Re: Lot 2 – 45B Crooked Pond Drive
DEP File # 114-1189

Lot 2 Crooked Pond Road - Pre

Summary for Subcatchment 1: Isolated Wetland/Vernal Pool

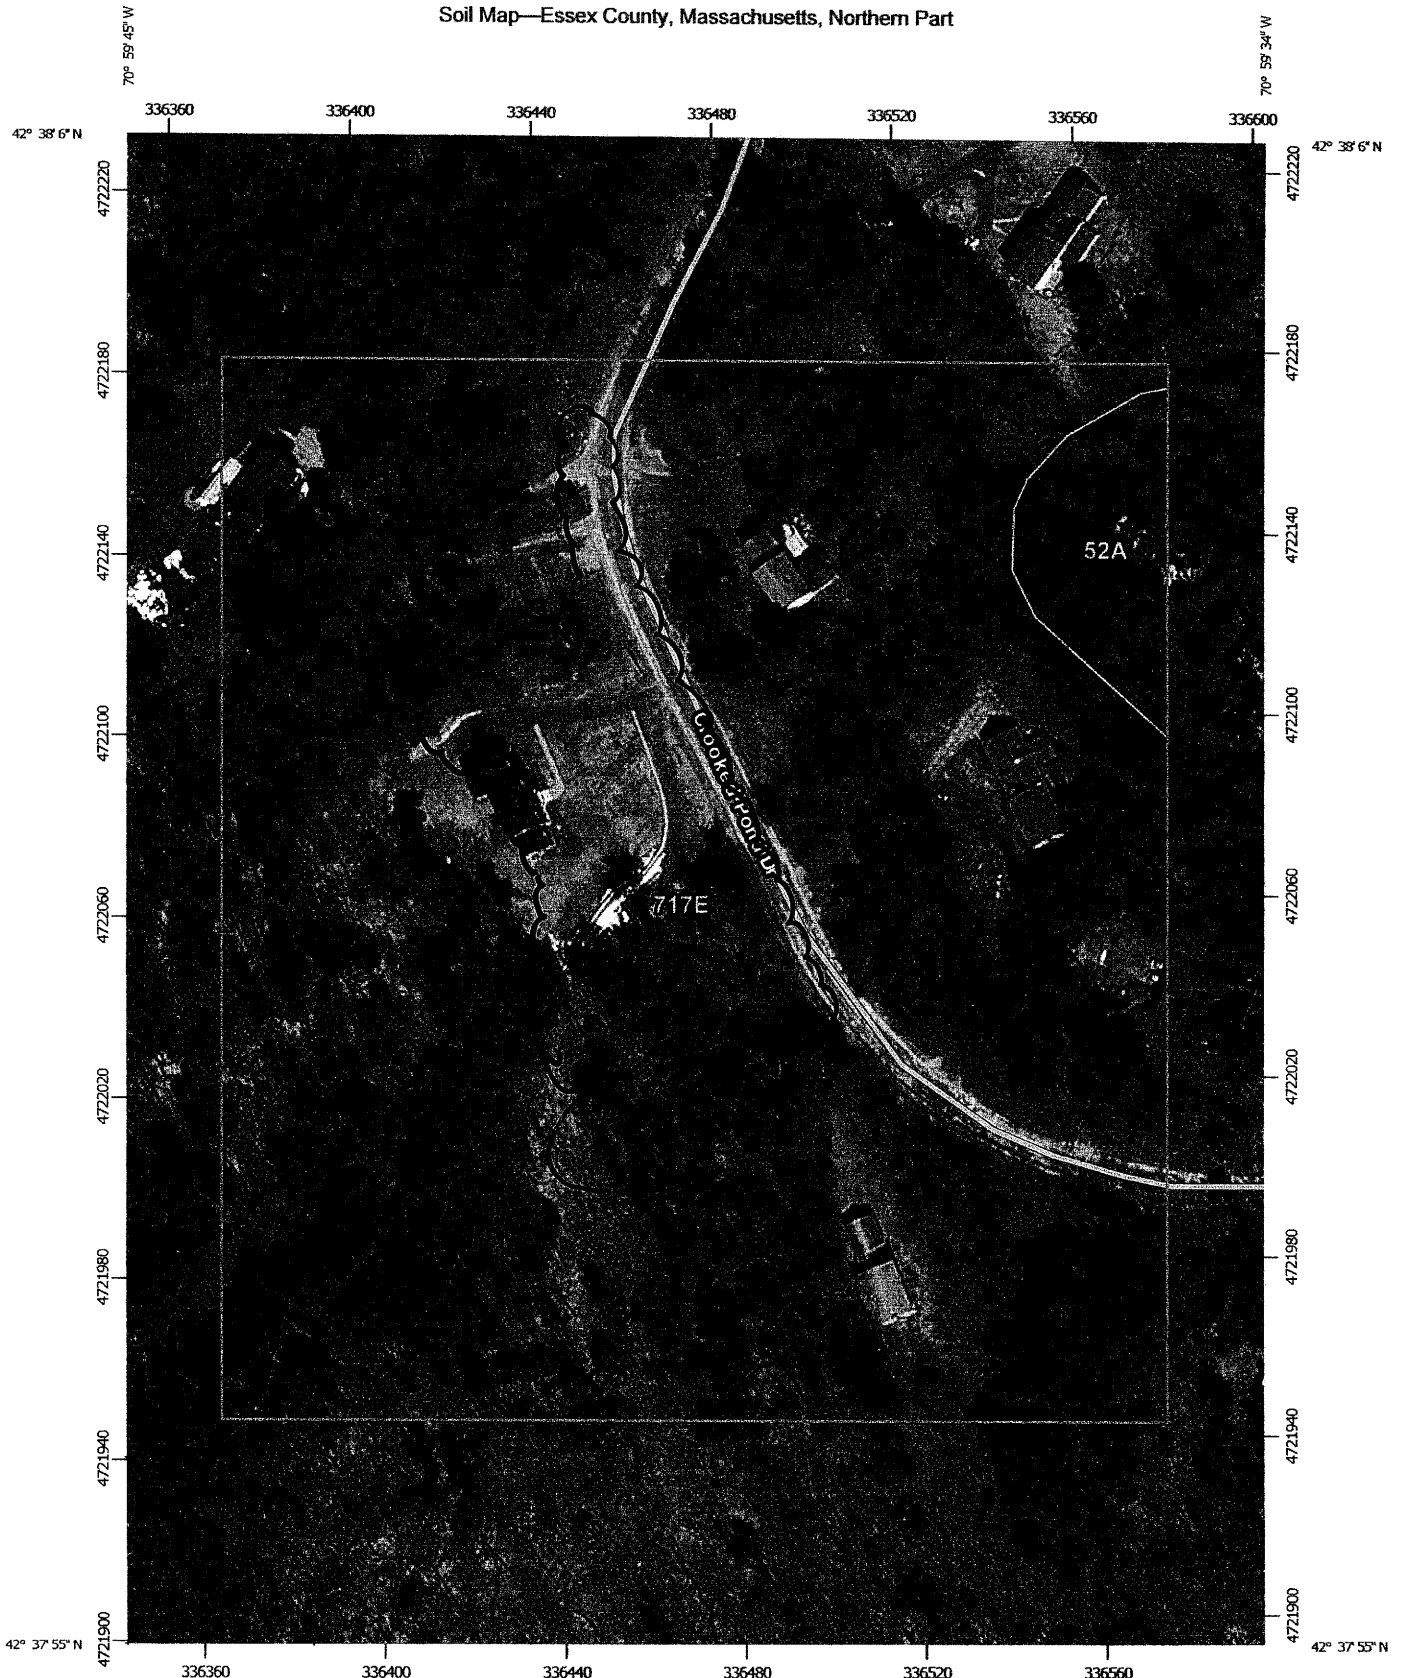
At the Conservation Commission meeting held on July 17, 2014 a question was raised if calculations were performed regarding the isolated 300 Series wetland/vernal pool to see if the area would qualify as Isolated Land Subject to Flooding (ILSF). Based on the size of the contributing watershed we did not perform those calculations as it appeared the watershed was not large enough to generate the runoff volume required to meet the criteria for ILSF. Please find attached calculations/plans that show that the contributing watershed to the isolated 300 Series wetland/vernal pool does not generate the required water volume to be considered ILSF.

In accordance with the Wetlands Protection Act (310 CMR 10.57(2)(b)) Isolated Land Subject to Flooding is an isolated depression without an inlet or outlet which, at least once a year, confines a volume of at least 0.25 ac-ft to an average depth of at least 6 inches. Please find attached an existing site conditions plan which shows the limits of the potential ILSF as well as the contributing watershed.

By examining the attached calculations for the 1 year storm event you will note that the drainage subcatchment contributing to the potential ILSF generates a volume of runoff of 0.13 ac-ft. Since this volume is less than the required volume of 0.25 ac-ft the area does not qualify as ILSF.

Runoff = 2.01 cfs @ 12.06 hrs, Volume= 0.126 af, Depth> 0.99"
